Appendix F  
*Storm Water Quality Management Plan*

CITY OF OCEANSIDE ENGINEERING DIVISION
<b>PRIORITY DEVELOPMENT PROJECT</b> <b>STORM WATER QUALITY MANAGEMENT PLAN</b> FOR Breeze Luxury Townhomes
ENGINEER OF WORK  _____ Ronald Holloway – RCE 29271 – 3-31-19

**RE: BREEZE LUXURY TOWNHOMES, T18-00009 – STORM WATER QUALITY  
MANAGEMENT PLAN – 1<sup>ST</sup> REVIEW RESPONSE**

**HYDROMODIFICATION  
 MANAGEMENT AREA EXHIBIT  
 BREEZE  
 (LUXURY TOWNHOMES)**  
 CITY OF OCEANSIDE, CALIFORNIA

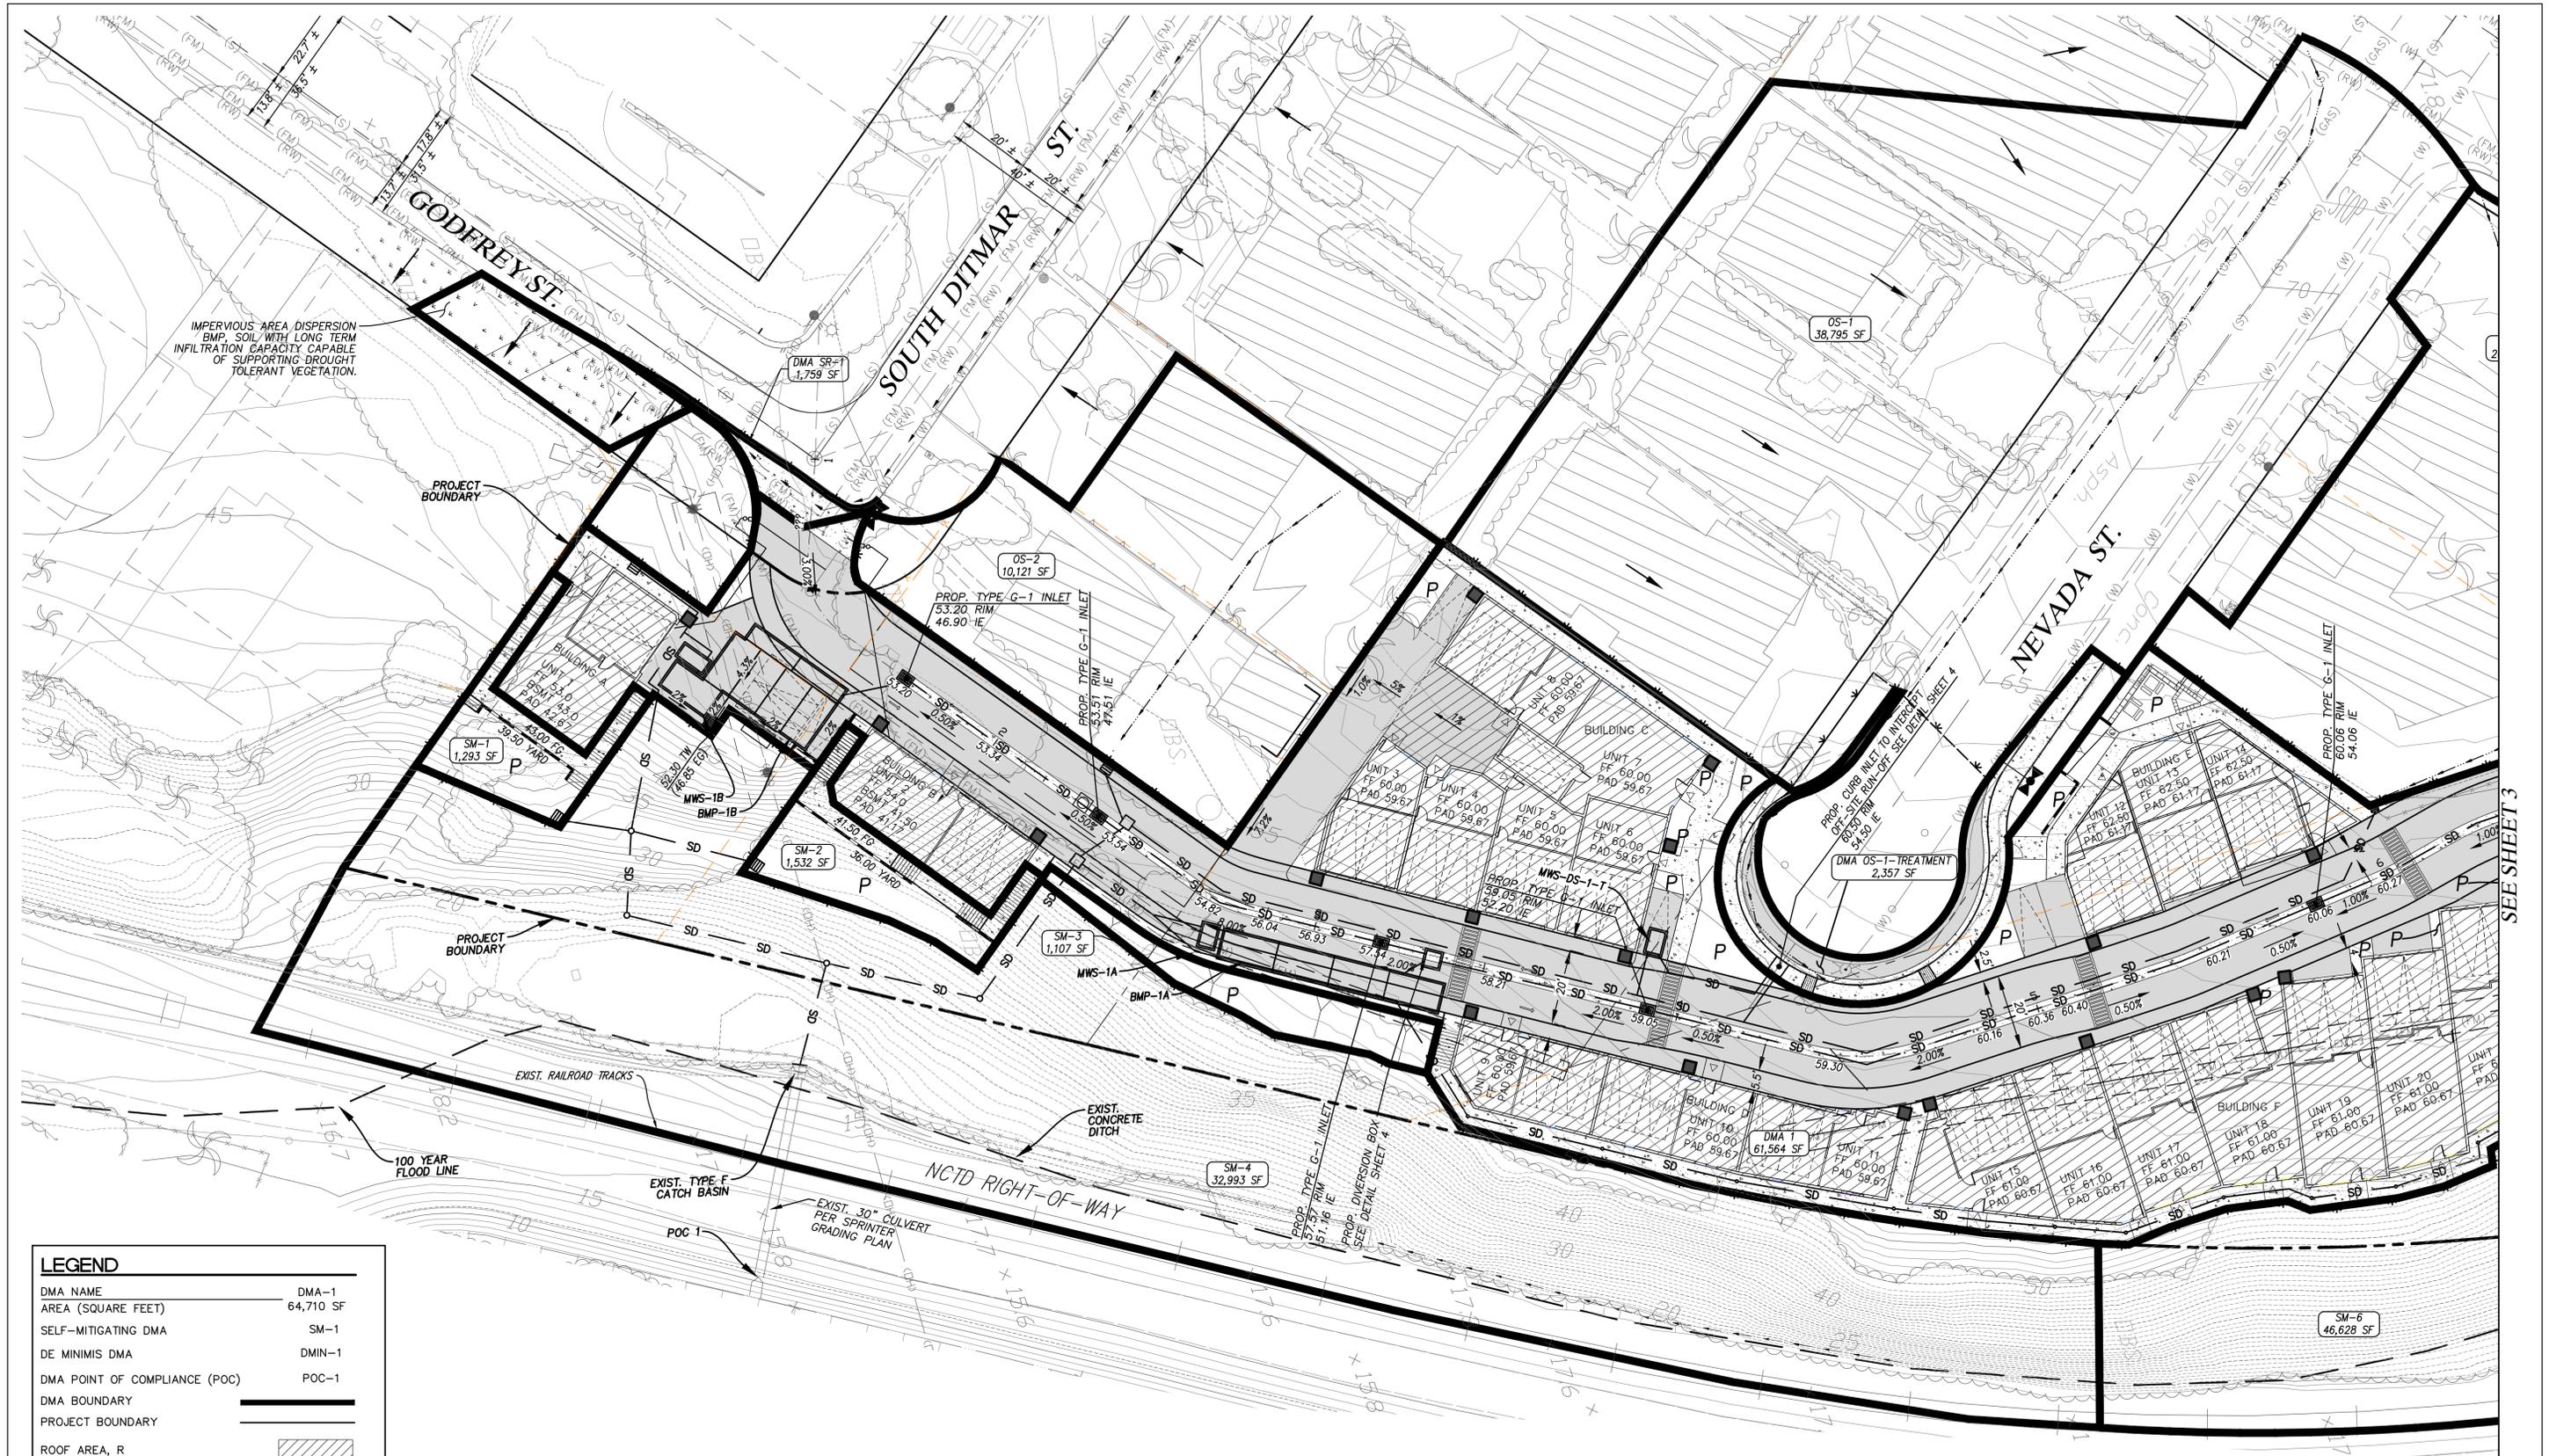
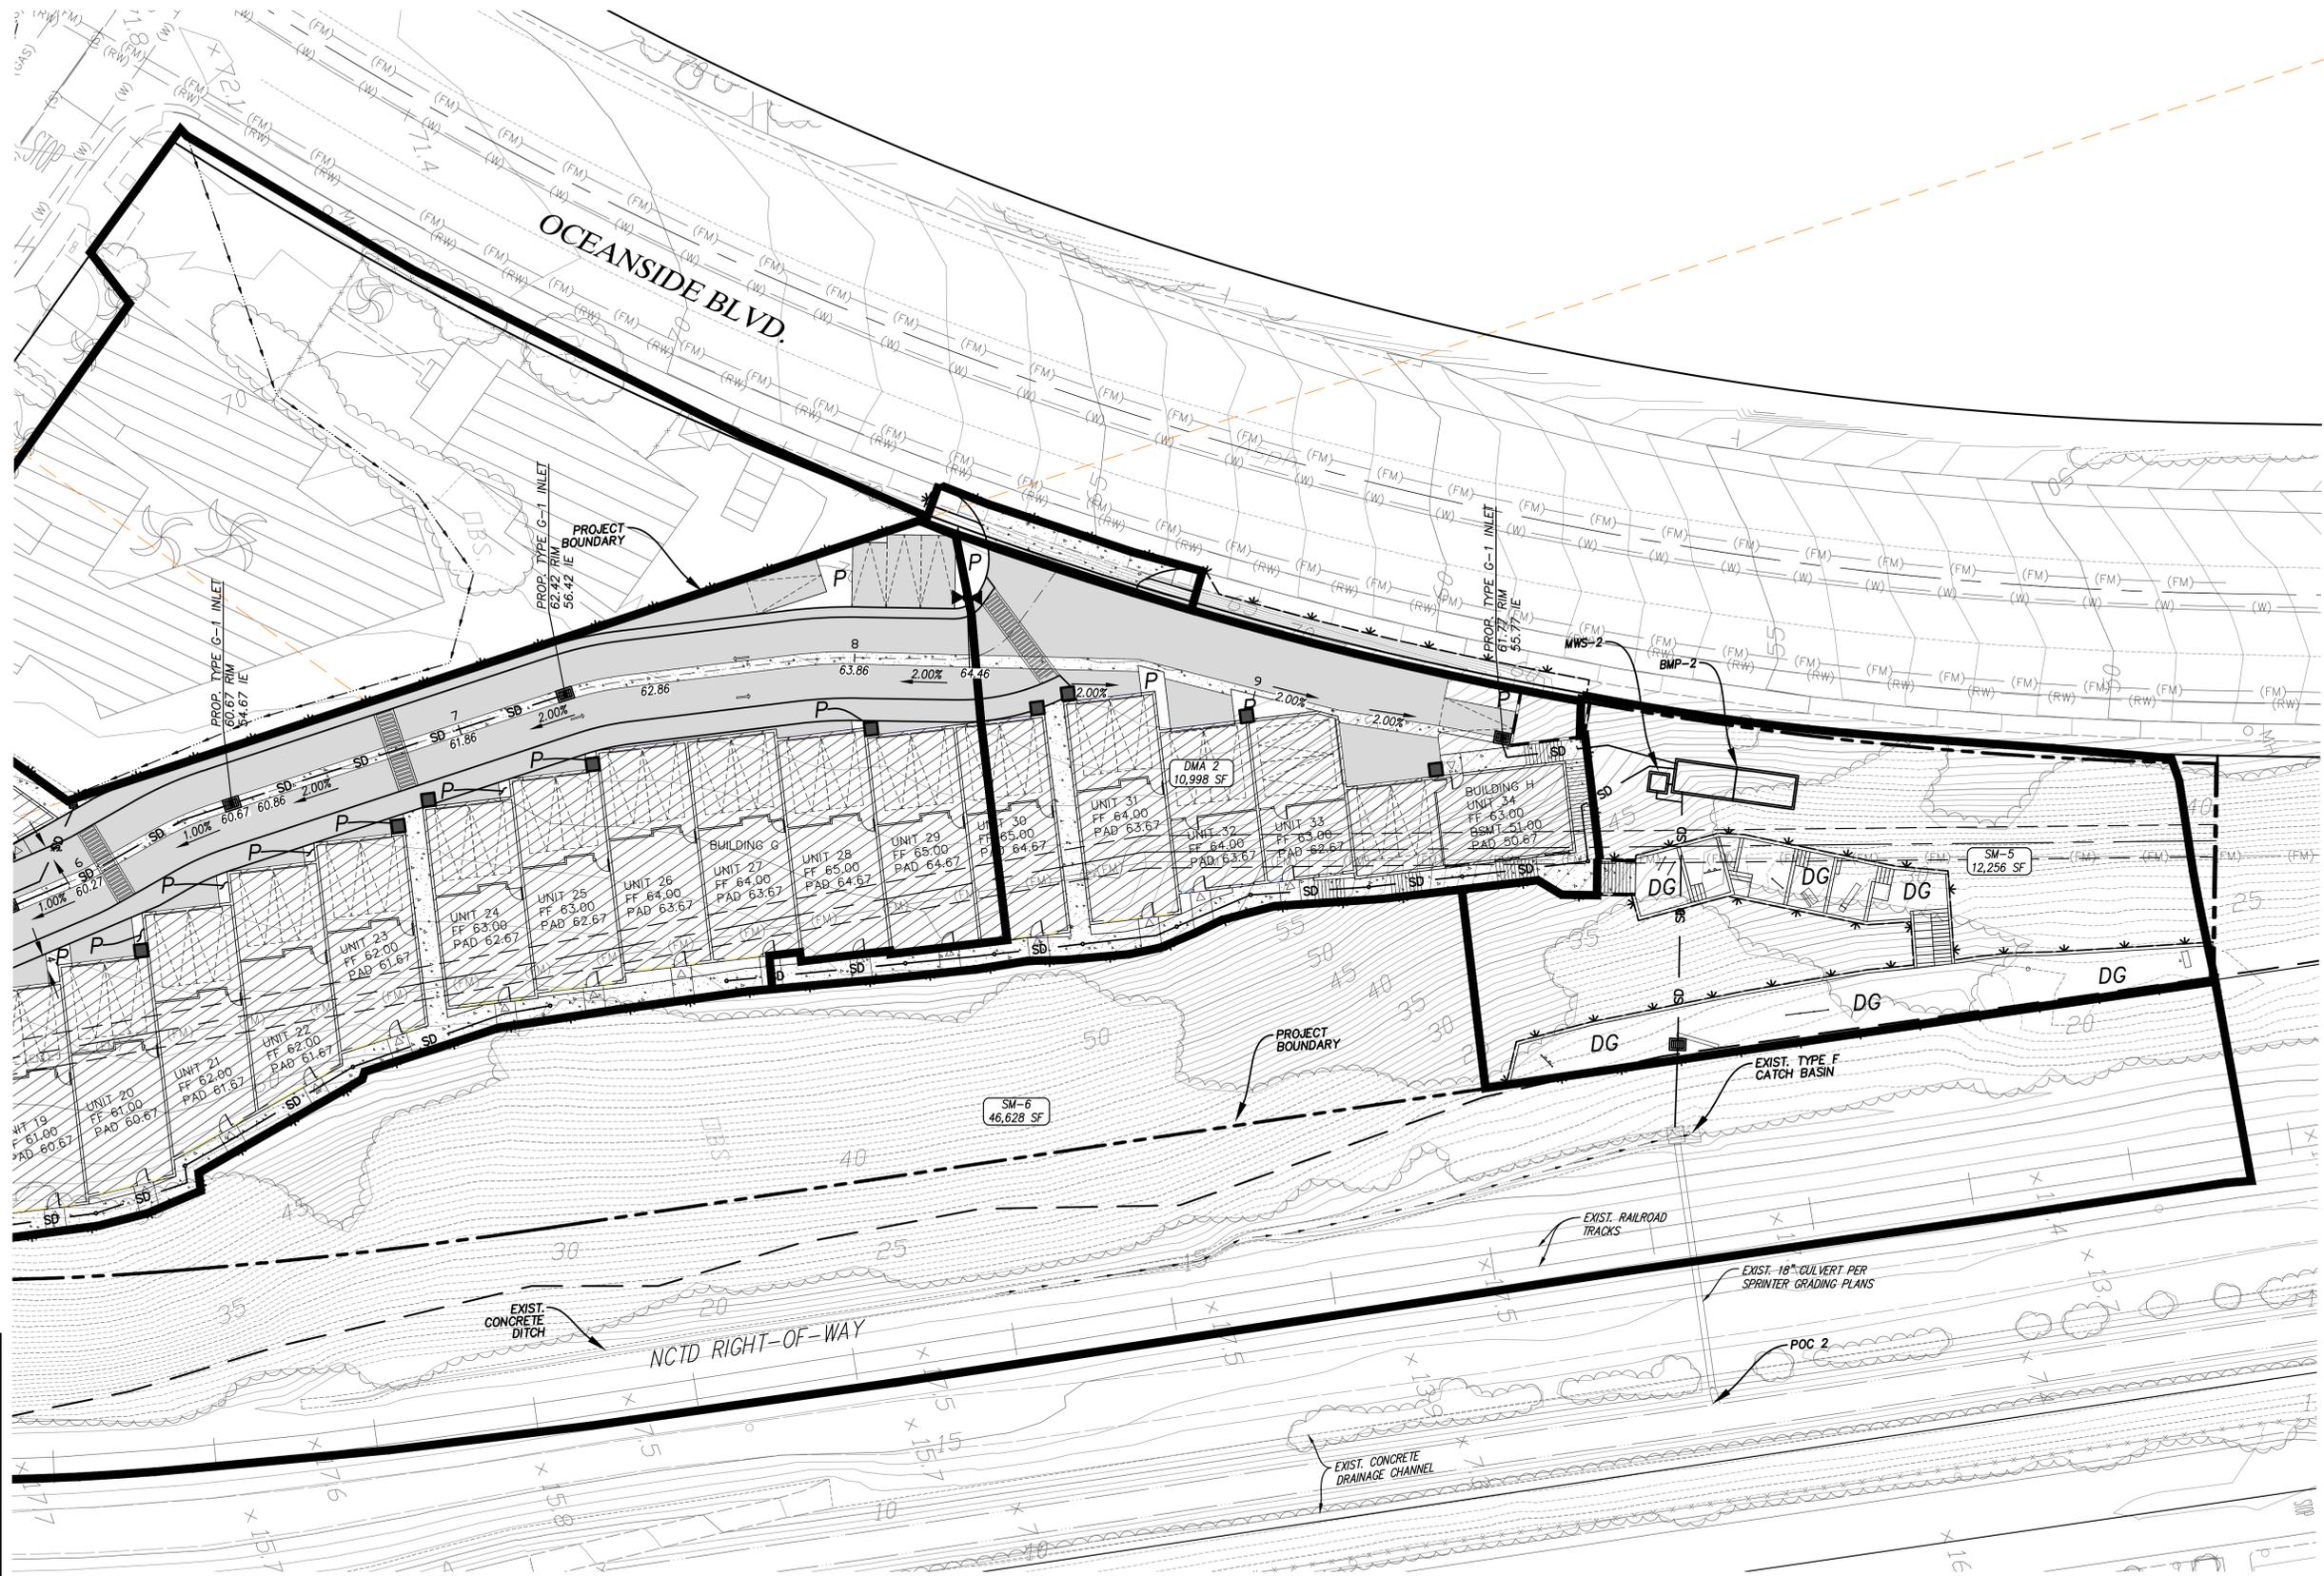
- A. The Hydromodification Management Exhibit is incomplete. Please address the following items and revise accordingly:

1. All items identified in Comment 8.A.1

*Have added topography and impervious area within the development footprint.*
